1. App# 2023-5371; 6672 E. Main St; Chase Bank; Major Site Plan

RE: Vaughn Benson; 6672 E. Main Street: Major Site Plan Application

Subject: Staff Report for: JP Morgan Chase Bank – East Main St and Rosehill Road

MAJOR SITE PLAN FOR
JPMORGAN CHASE BANK
6672 EAST MAIN STREET
REYNOLDSBURG, OHIO 43068

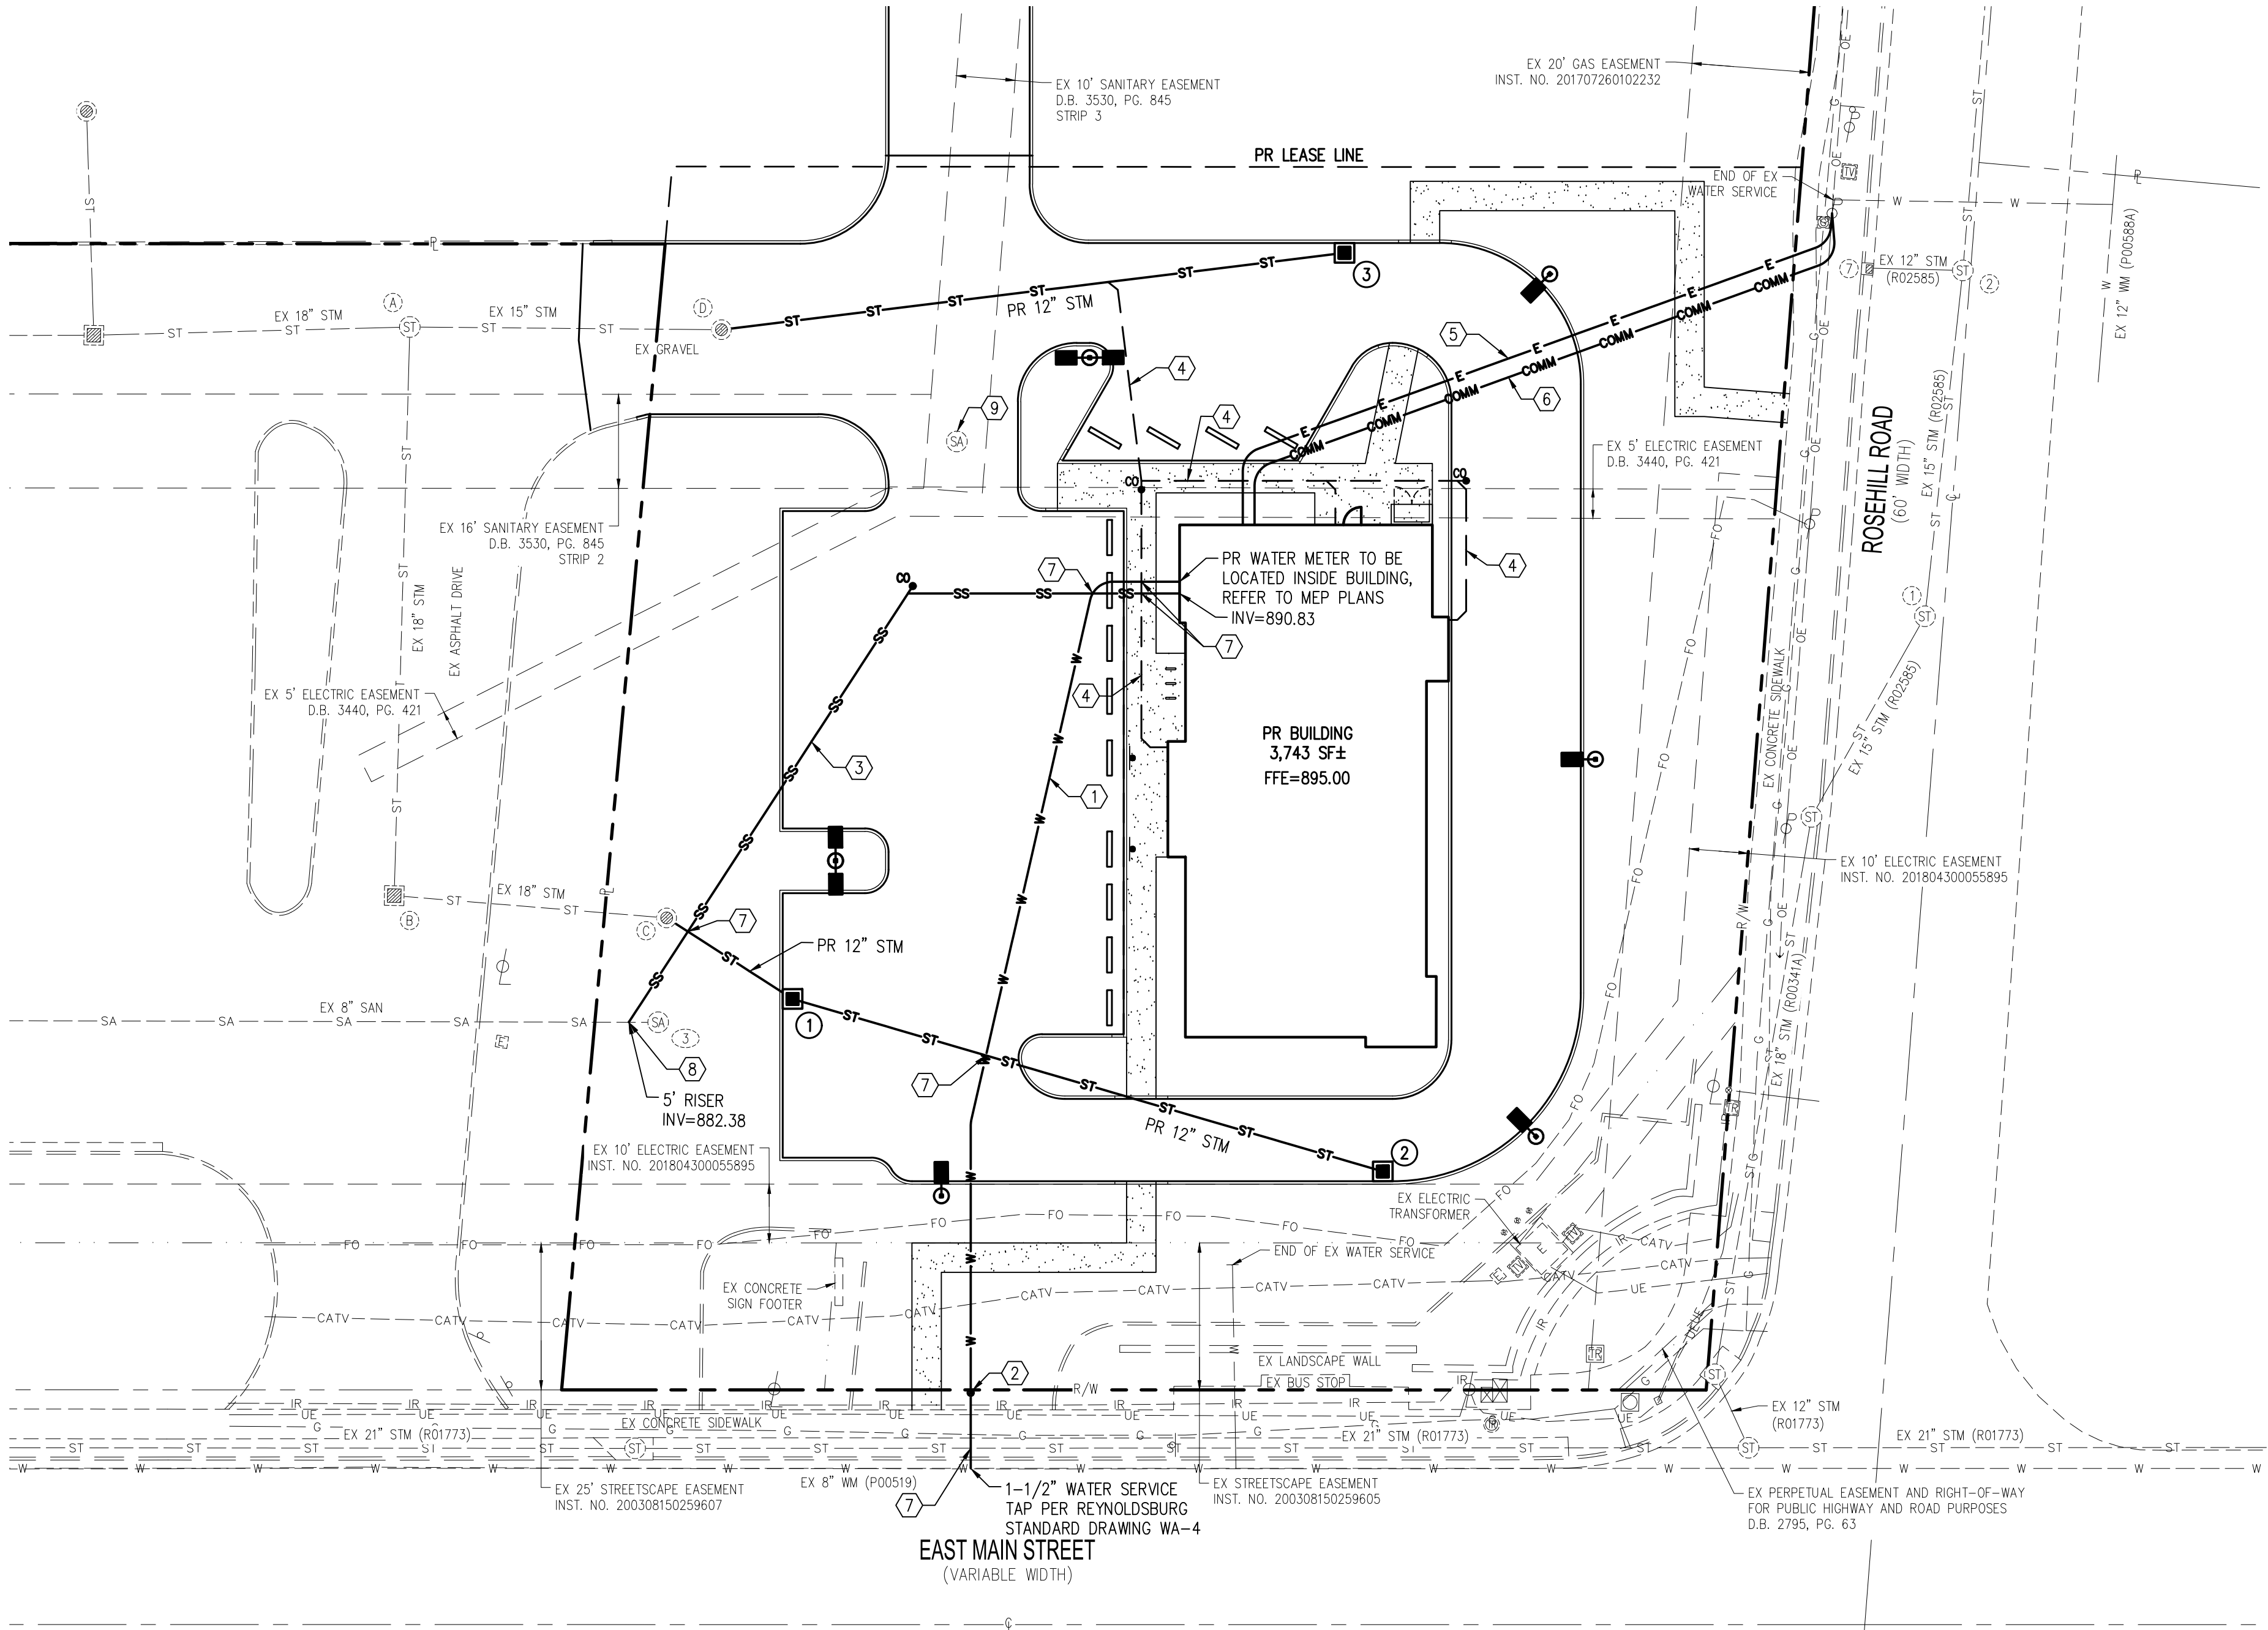
9. The project proposes to tap into the existing 8-inch watermain located on the north side of East Main Street via a 1.5-inch water service line extended into the site with the water meter to be located inside of the building.
10. As shown, sanitary sewer service will be provided via a proposed lateral extended into the site from an existing 8-inch line on the north side of East Main Street. The existing sewer connection point has been further investigated by EMH&T and there may be access as originally thought, even though previous Kroger plans indicated that the sanitary line was to be "Removed and Disposed of". Final confirmation may entail inspection of the existing manhole in that area.
11. A site photometric plan was previously provided. Please also include with PGU submittal.

12. The utility plan shows a total of three catch basins in the parking and drive areas. The storm sewer is shown outletting into existing storm sewer to the west at the fueling station. Based on the Kroger plans, this appears to be the correct location as the existing underground detention system appears to have been sized to include this outlot. This will need to further investigated and confirmed with PGU.
13. Further grading information in the way of spot grade elevations will be needed with the PGU.

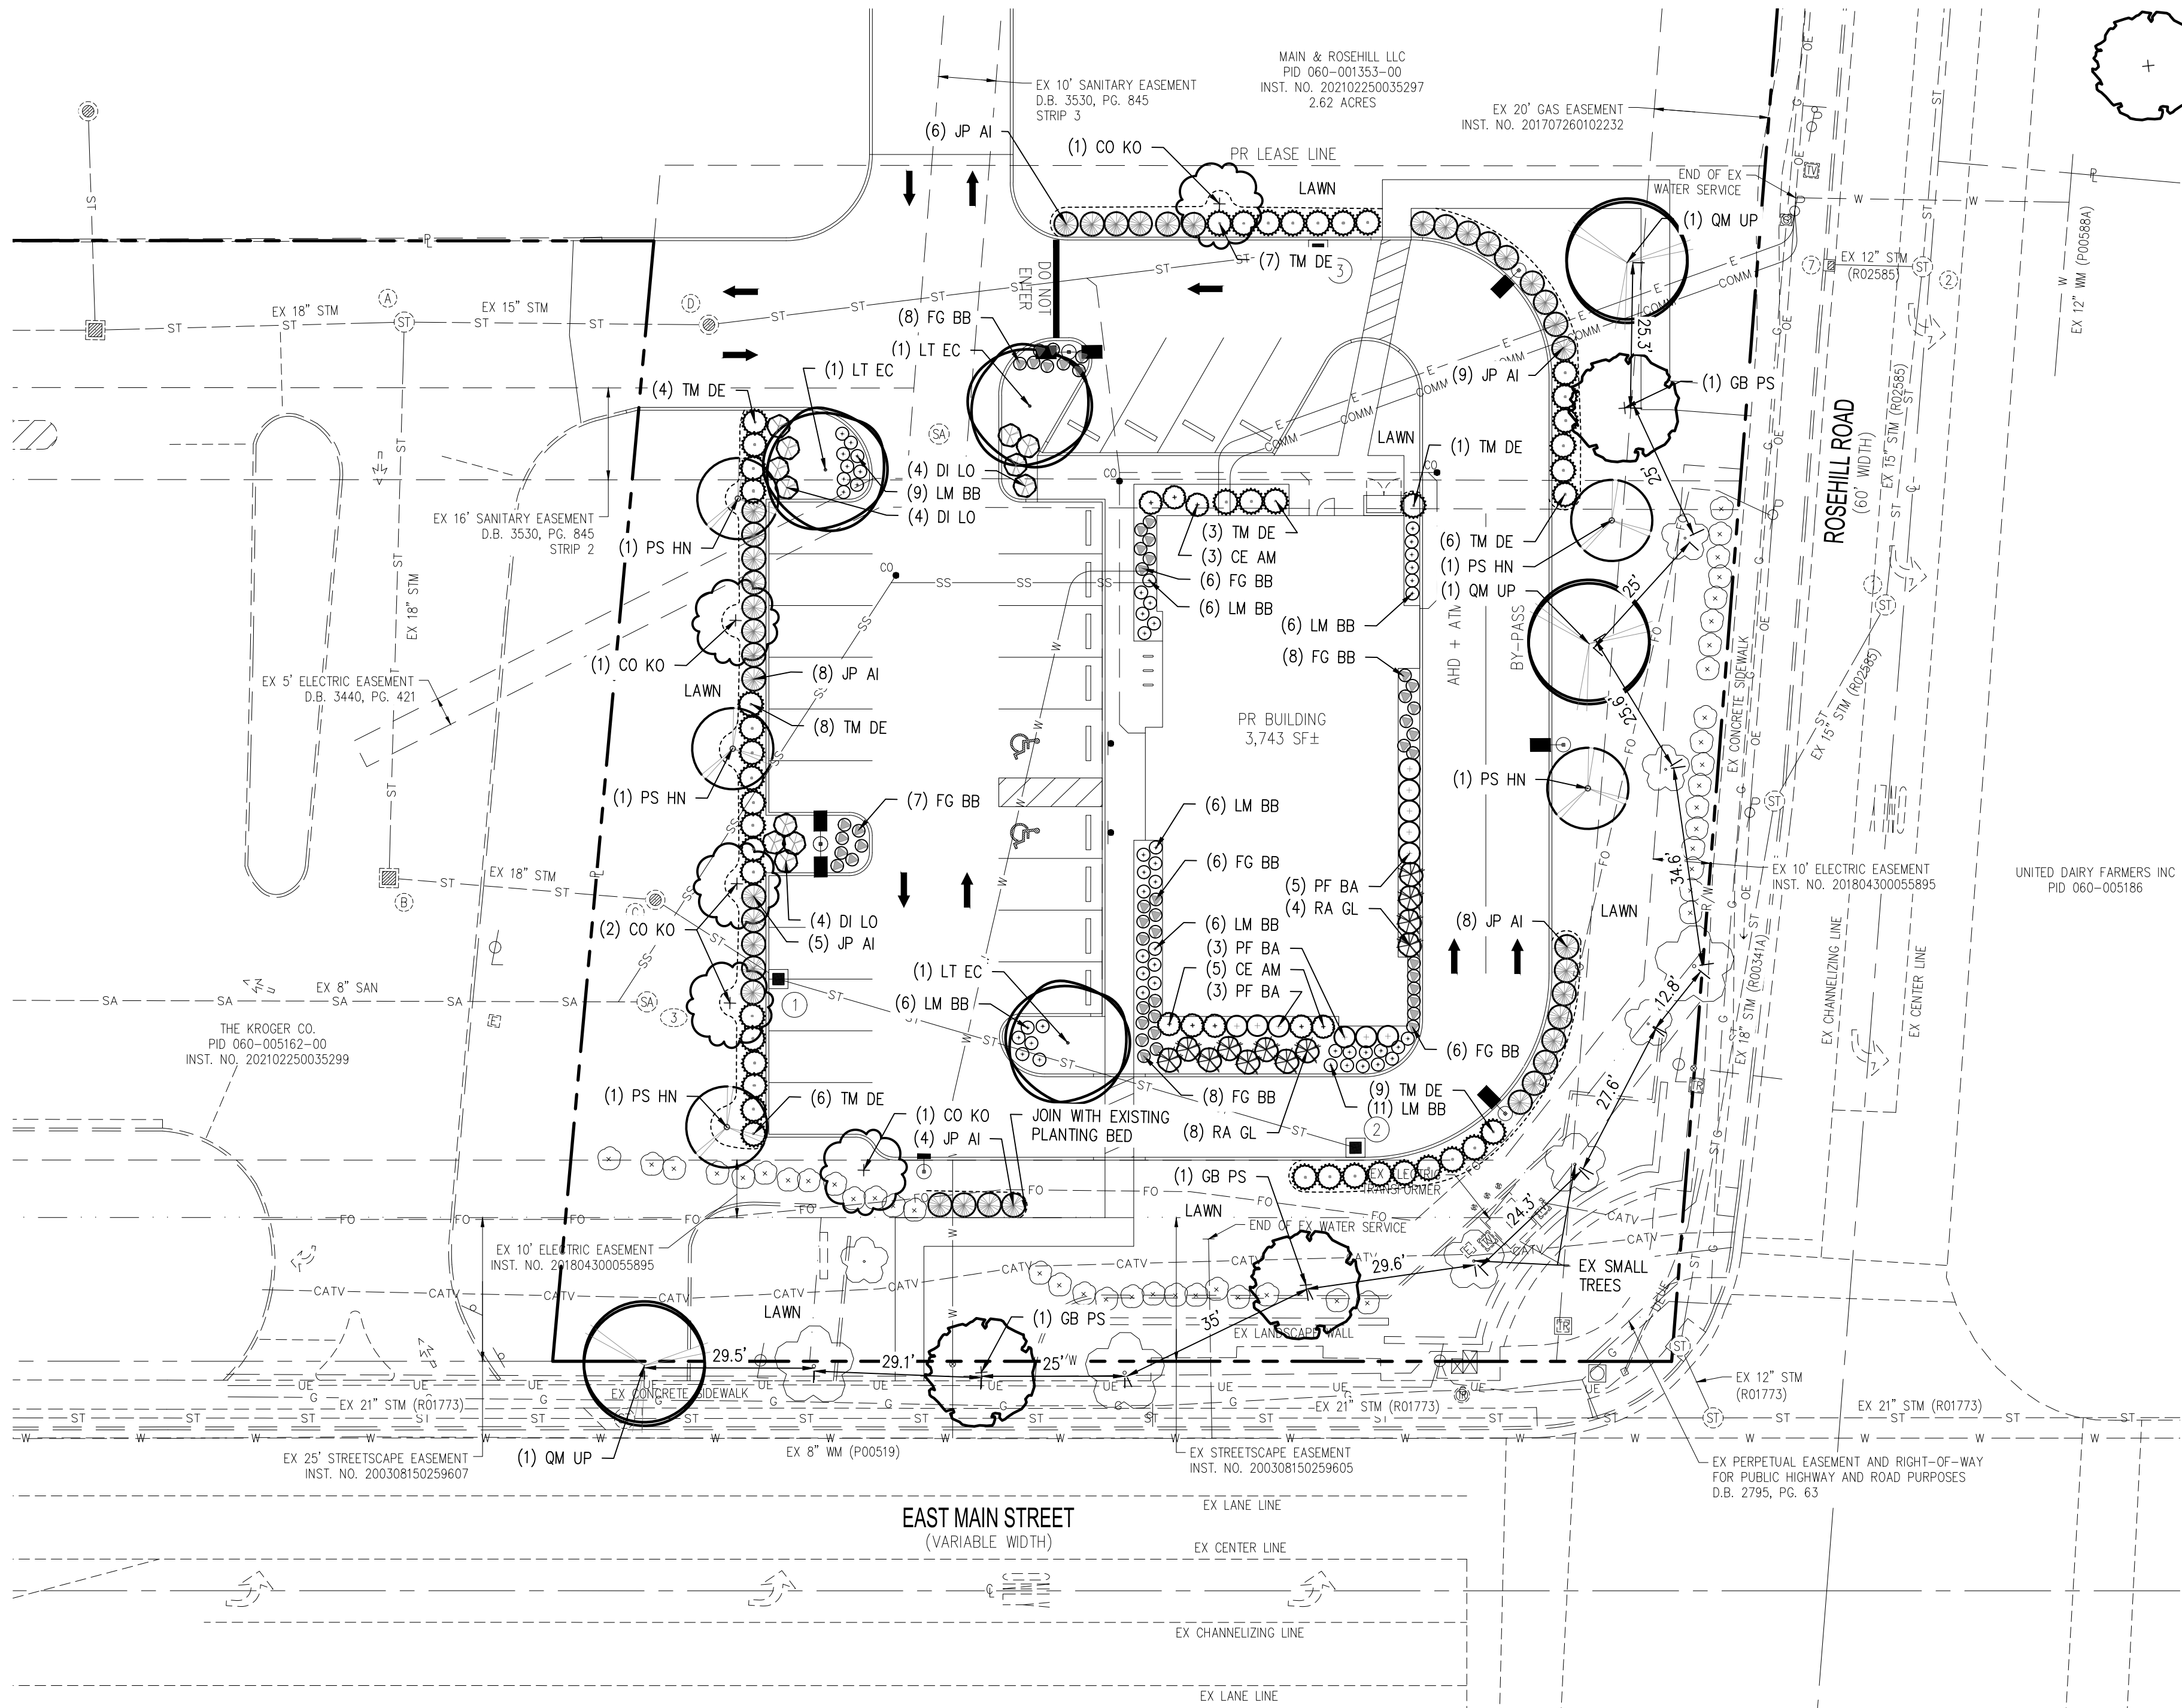
- ii. **General Landscape Standards:** The required landscape setback is a minimum of 6 feet. The applicant states they have provided a 6 foot landscape setback, however the site landscape plan does not depict the setback. The applicant will need to show on the landscape plan, the required minimum 6 foot landscape setback.

- iv. **Interior Lot Landscaping:** Per zoning, the applicant is required to provide 10" of tree trunk diameter for a site with 19,815 square feet of building and ground coverage on the site. The applicant is providing 14" of tree trunk diameter on the site, and meets the code requirement. The applicant states there is 33" of tree trunk diameter provided, however only 7 deciduous trees with a minimum caliper of 2" is provided on the landscape plan, within the parcel. The Landscaping Code Requirements will need to be updated to reflect the correct number.

- a. Staff recommends approval of the Major Site Plan with the following conditions:
 - i. On the lighting plan, change the parking lot light pole height from 25 feet to 20 feet in height. Section 1105.09.B.ii
 - ii. On landscaping site plan, depict the 6 foot minimum landscaping setback line on the site plan. Section 1105.07.F.ix
 - iii. On the Landscape site plan, update the Landscape Code Requirements table, H.i.2 to state 14" provided throughout interior landscaping. Section 1105.07.H.i.2.a
 - iv. Have the applicant provide more detailed information regarding the trash enclosure such as height, material and opacity to meet the code requirement. Section 1105.07.K.ii
 - v. Provide two physical and one electronic updated Major Site Plan copy to staff, showing the required changes have been made, to meet the conditions mentioned above.
